ADDENDUM - 1

ADDENDUM TO BOILER SPECIFICATION
(BOTTOM ASH HOPPER)

MAHARASHTRA STATE POWER GENERATION CO. LTD.	VOLUME - VI
	KORADI THERMAL POWER STATION 2X660 MW UNITS - 11 & 12 PROJECT	-
	RFx No. 3000046202 (BTG Package)	ADDENDUM - 1
	ADDENDUM TO BOILER SPECIFICATION (BOTTOM ASH HOPPER)	REV. - 0

Visitor Gallery
View-2

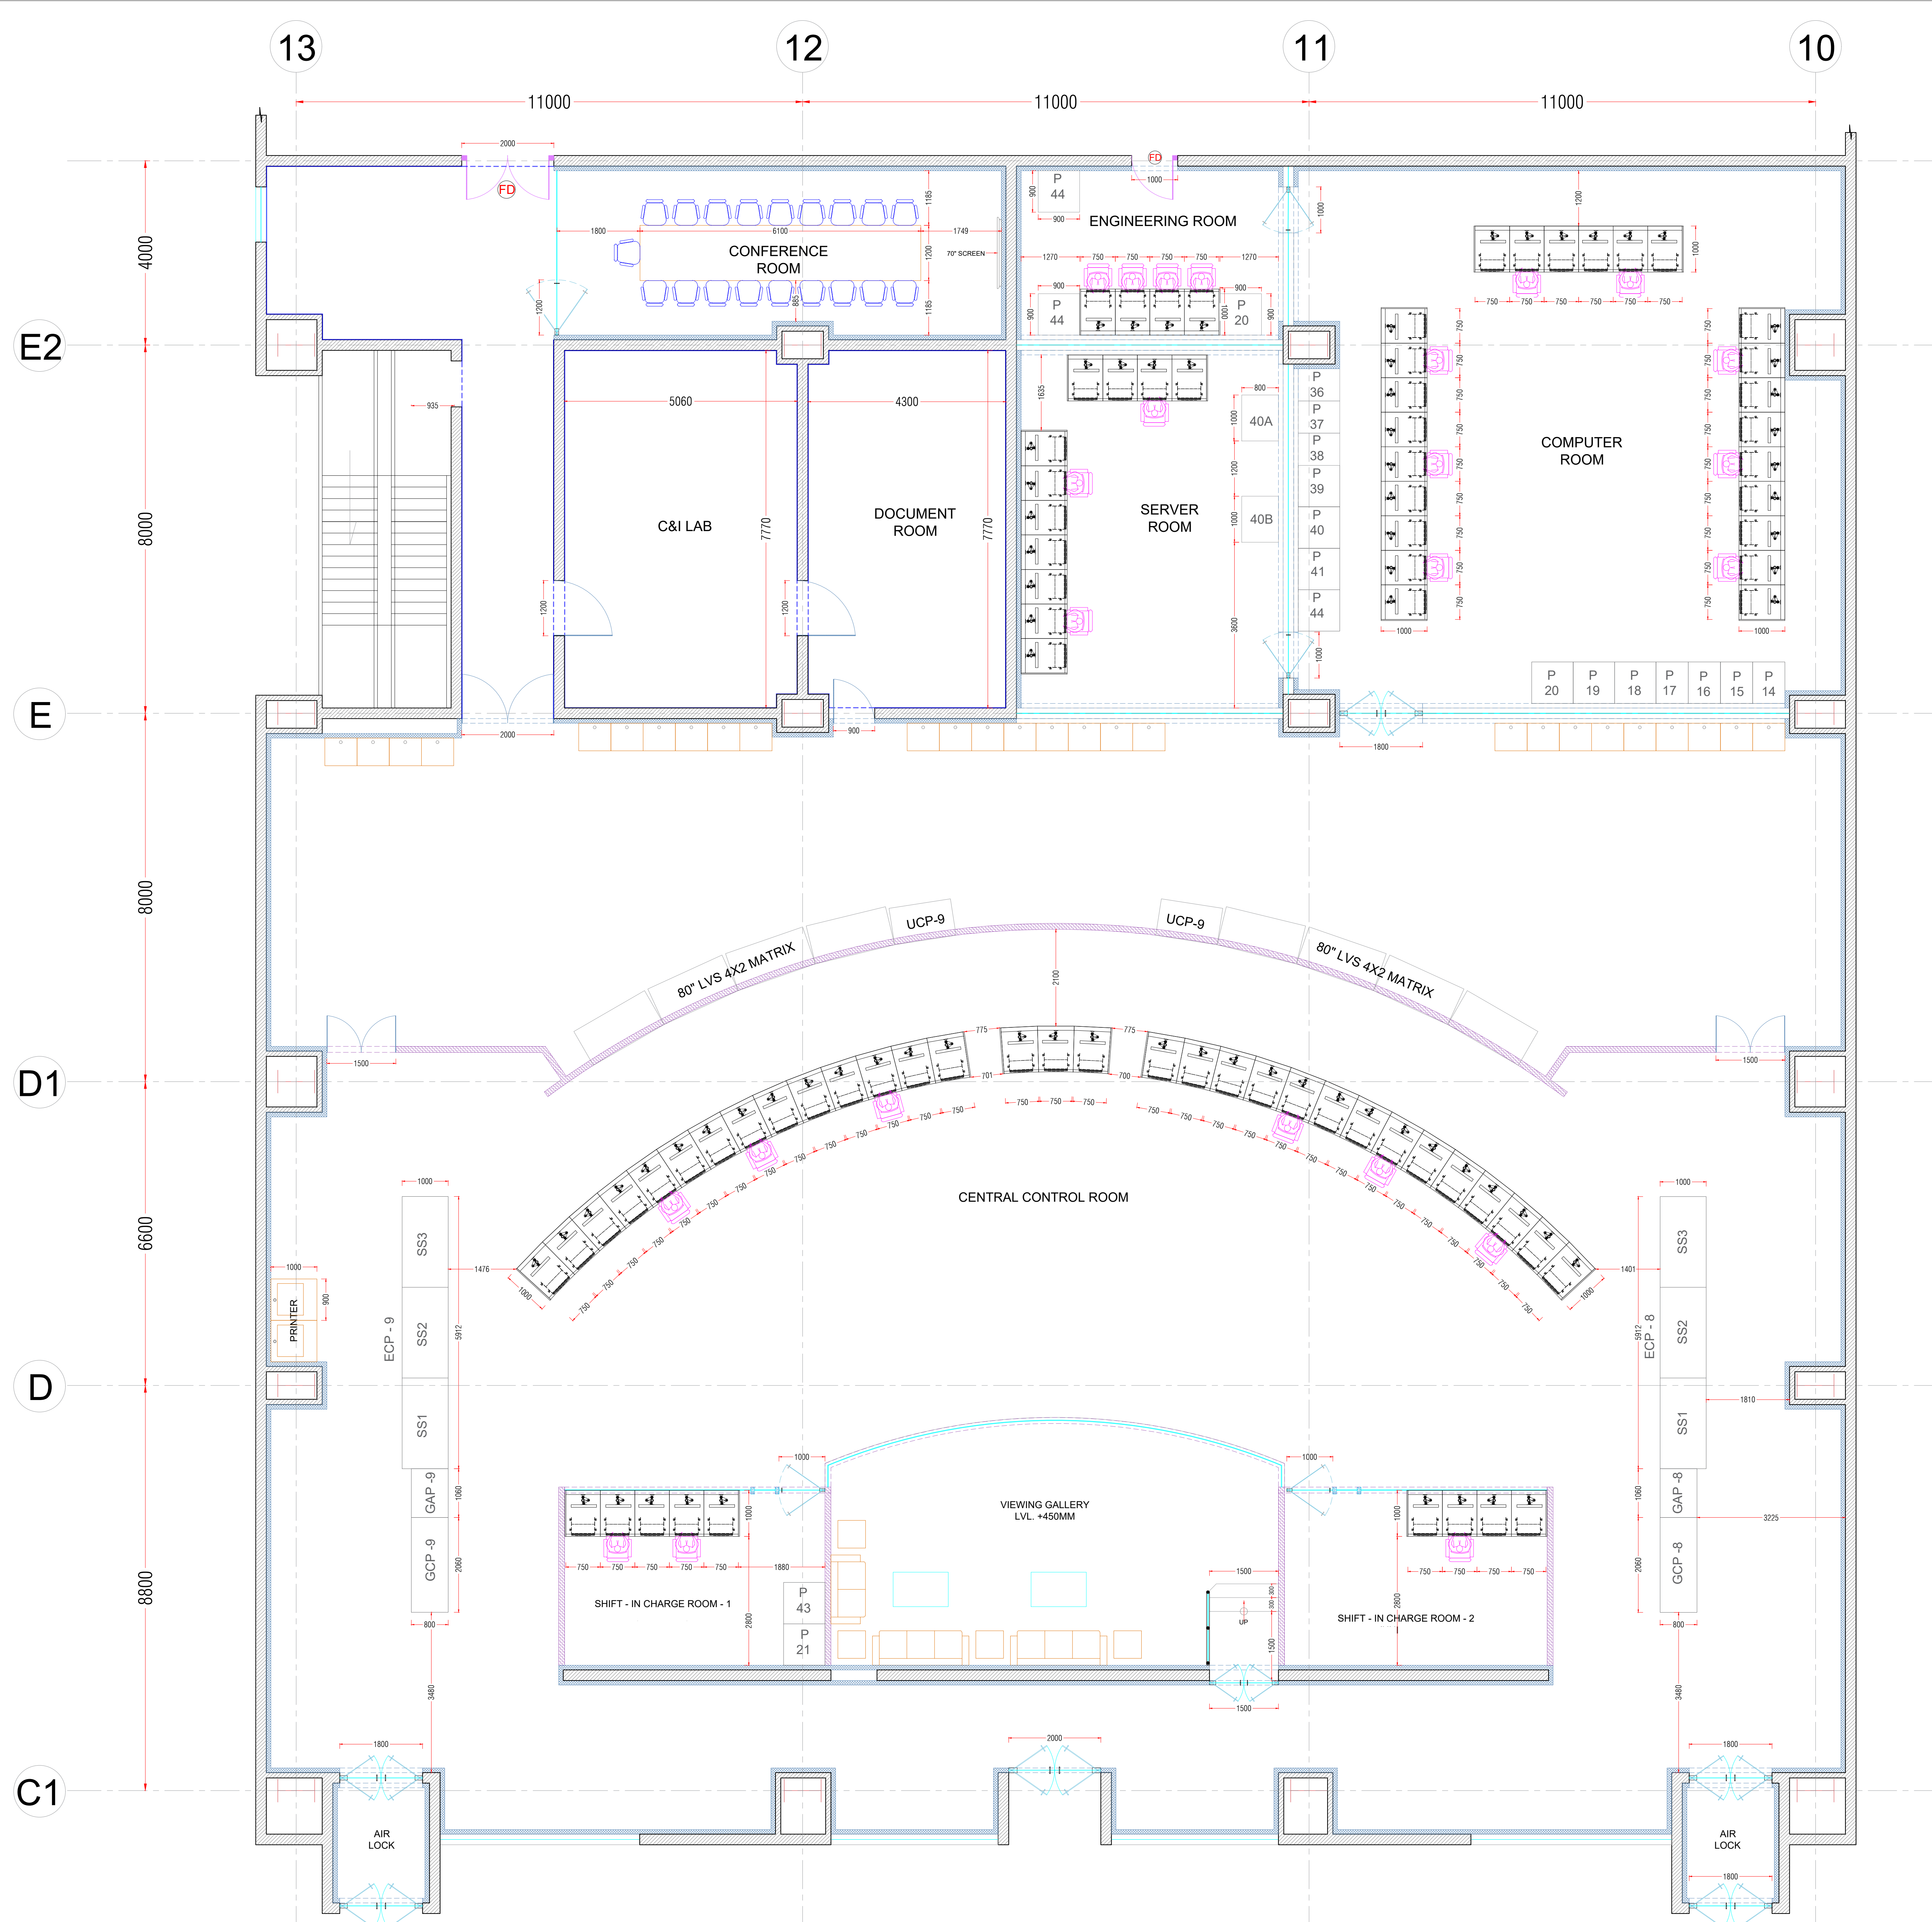
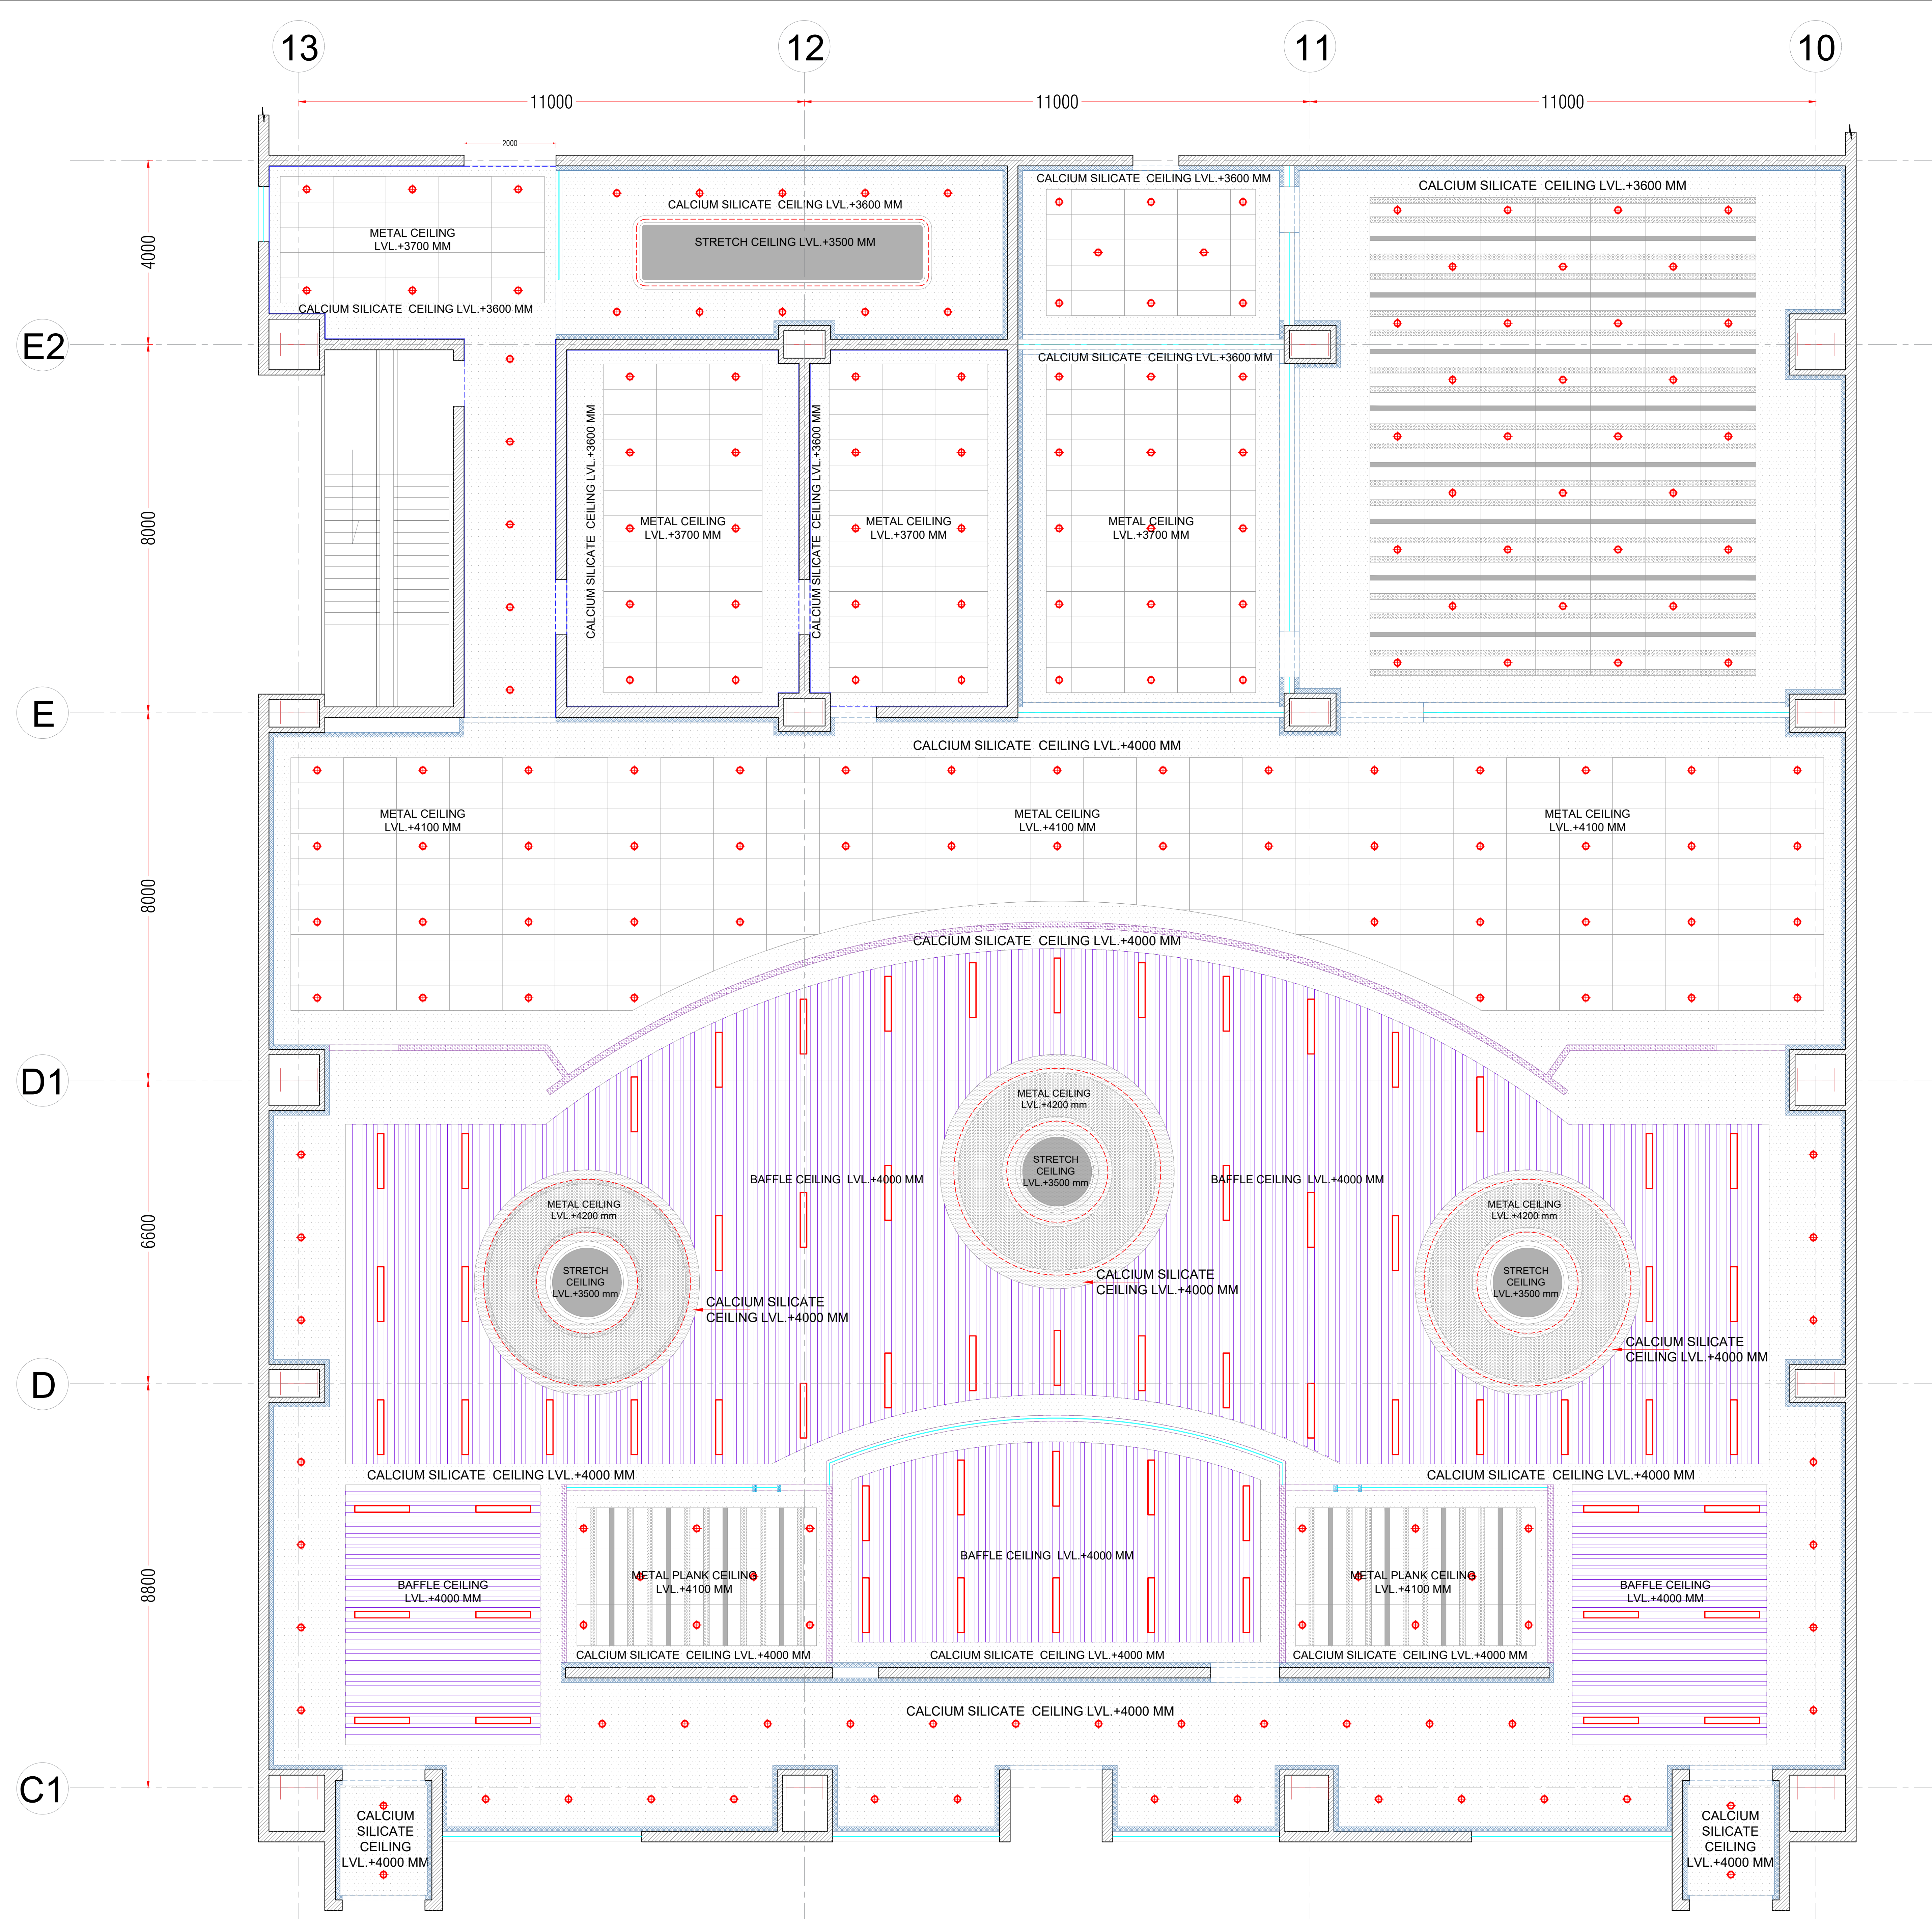
- i) 24/7 Safety Control room is envisaged for monitoring safety in plant area. The Contractor shall provide all hardware and software including IP based CCTV camera, Drone, loudspeakers, Redundant Servers/PC workstations, network switches, furniture, power supply, cables, Joystick etc for meeting the above requirement. For quantity refer below in this sub section.

- ii) Contractor shall supply and install IP based CCTV system along with IP based announcement system which shall be used for monitoring safety during construction from Safety control room. It shall be possible to make announcements to alert the workers whenever required. These cameras shall be installed at all strategic locations in the plant area. These cameras can be wired or wireless as per suitability at site. Initially these installations will be temporary & locations will keep on changing depending upon the work in progress. After completion of last Unit these cameras are to be installed permanently at suitable locations in consultation with Owner.

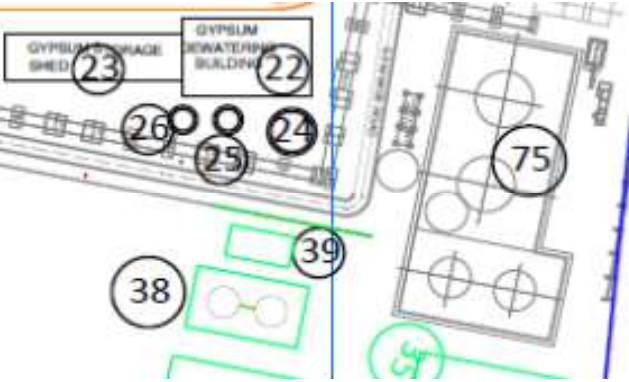
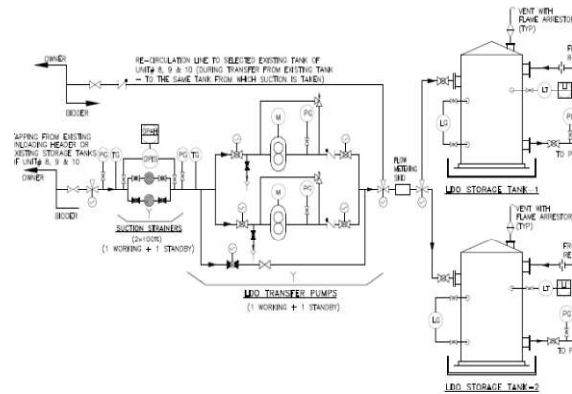
148	Volume - III, Part - A, Section - 7 Technical Specification Mechanical AC & Ventilation System	Doc No. ETG061-BTG-ME-HVAC-TS / Page-23 & 24		4.23.00	Point - 5 : Chiller Insulation - As required and Finishing as per manufacturer's standard Point-8 : Chiller Insulation - Nitrile Rubber (Slab/Roll)	Bidder considers to provide Chiller insulation as per manufacturer's standard with reference to point-5, Please confirm	Noted

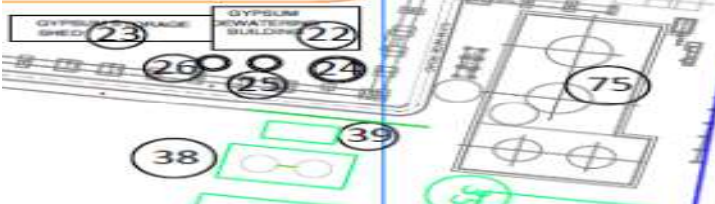
268	Volume-III	Part-A/Section-1		6.05.05	Fans – (FD) Blade type : Backward curved, aerofoil type	It is clarified that the offered FD Fan is Axial type with Aerofoil bladed type design	Noted
269	Volume-III	Part-A/Section-1		6.05.10	Fans – FD Material of construction i) Fan scroll: Lined with abrasion resistant material ii) Suction chamber: IS 1079 / 73 SH. 34 iv) Shaft: SAE 1045 forged normalised and tempered steel v) Sleeves: High grade Babbitt vi) Regulating vane: IS 1079 / 73 viii) Bearing Housing : Grey cast iron	i) Fan scroll applicable for Radial/Centrifugal Fans. As the offered FD Fan is Axial reaction type, Fan scroll is not applicable. ii) Suction chamber shall be provided with IS 2062 with minimum 6mm thickness iv) Fan shaft material shall be 42CrMo4 of forged, quenched and tempered steel. v) Sleeves are envisaged in Journal bearing design Fans. As the offered FD Fan is of Axial reaction type with antifriction bearings, Sleeves are not applicable. vi) As the offered FD Fan is of Axial reaction type with blade pitch control, regulating vane is not applicable. viii) As per the OEM standard, offered bearing housing will be of Alloy Steel All the above were in line with BHEL Supplies for MAHAGENCO Bhusawal 1X660 MW EPC Package.	Noted.

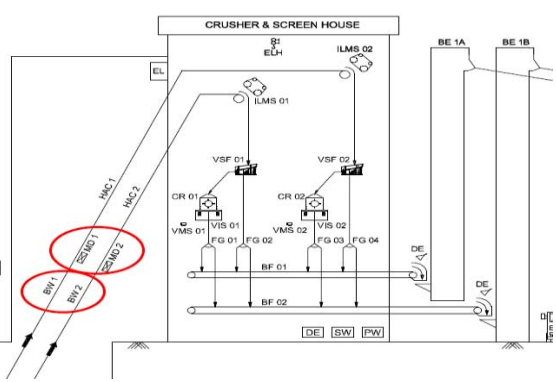
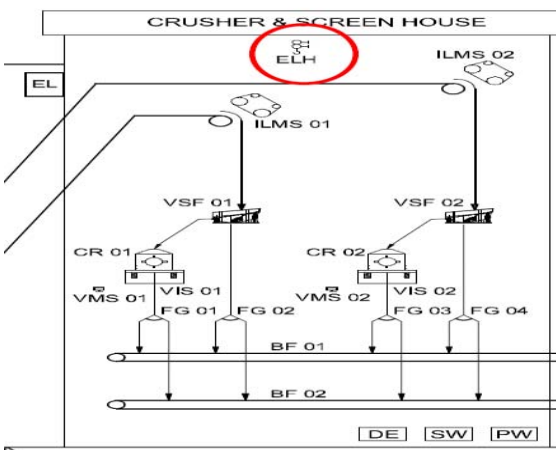
Sl. No	Particular	Details																							
II.	Sealing air system duct from damper frame to isolation damper	ASTM A588 or ASTM A36 or IS 2062																							
17	VOLUME - III	PART - A/SECTION - 4		3.31.03	Dumper unloading platform for tippling of Limestone from dumper, Rod gates, Rack & Pinion gates and Vibrating feeders, separate dedicated DE system for unloading facility	We understand there is no requirement of Truck tipplers as customer shall be bringing self tippling trucks. However we request you to kindly clarify what is the meant by "Dumper unloading platform", so accordingly same can be considered by bidder.	For Limestone unloading no TT required. LS shall be brought inside through self tipping dumper. Platform if any required shall be suitable for dumper movement. However, entire area shall be covered as per specification with remotely operated shutter gates

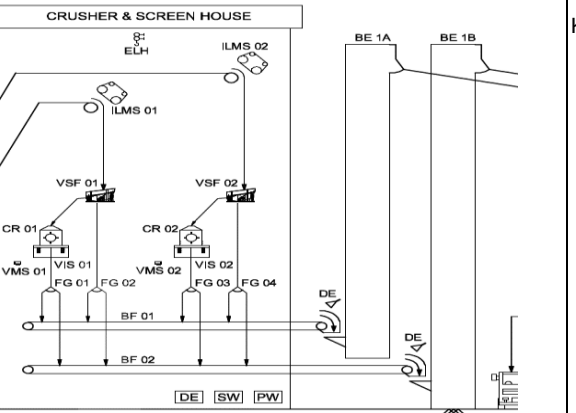
22	VOLUME - III	PART - A/SECTION - 4		3.31.12	vi) Valley angle of hoppers shall be minimum 60 deg. The unloading hopper holding capacity shall be 60 MT.	We understand 60 MT is water filled capacity. Incasse, volume of hopper is to be calculated using the heap formation in hopper, customer to specify the angle of repose of limestone.	Holding capaity of unloading hopper shall be 60 Ton of limestone storage Bidder can consider angle of repose, as per standard; 34 to 38 degrees
23	VOLUME - III	PART - A/SECTION - 4		3.31.15 CRUSHER & CONVEYER BELT	Sufficient number of crushers and Screen/Feeders & belt conveying system, as per the proven practice of the bidder, shall be provided for limestone feeding system for continuous operation of the FGD system	1. We shall be considering inline with the flow diagram ETG061-BTG-ME-FGD-PFD-001, Rev 01. & Clause no. 3.31.07 "Lime stone crushing system shall consist of two nos. of Grizzly deck vibrating screens and two nos. of Crushers... " 2. Kindly specify the rated/design and gauranteed capacity of Crusher and screen.	1. Noted 2. Specified above

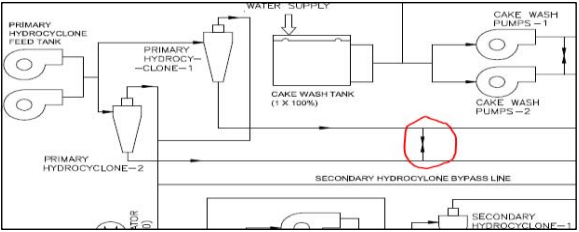
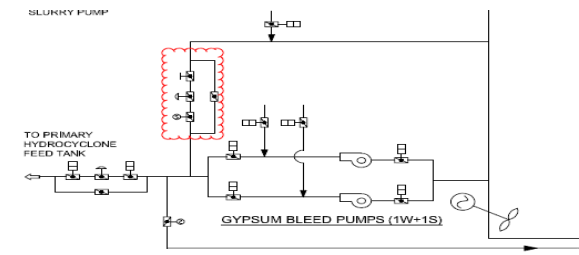
125	VOLUME - III	PART - A / SECTION - 4		3.38.04	Interior surface of the tanks shall lined with replaceable chlorobutyl/bromobutyl rubber lining of minimum 5 mm thickness and the outside surface shall be coated with paint as approved by the Owner.	Kindly note as per our standard practice interior of tanks shall be lined / coated as below: ●Limestone Slurry Storage Tank, Waste Water Tank, Primary Hydrocyclone Feed Tank, Auxiliary Absorbent Tank shall be CS+Replaceable chlorobutyl/bromobutyl rubber lining of 4 mm thick. ●Filtrate Water Tank, Secondary Hydrocyclone Feed Tank, Waste Water Tank, Additional Waste Water Tank shall be CS + Vinyl ester based flake glass lining of 3 mm thick or CS+Replaceable chlorobutyl/bromobutyl rubber lining of 4 mm thick. ●Absorber Area Sump, Limestone Area Sump, Dewatering Area Sump, Auxiliary absorbent area sump shall be Concrete+resin mortar Lining of 5 mm thick. ●Process water tank and clarified water tank shall be epoxy coated. This is inline with all ongoing major projects including NTPC. Please confirm.	Rubber lining thickness of the tank shall be minimum 5 mm as per specification, however bidder may consider minimum 3 mm glass flake lining of the tank and sumps
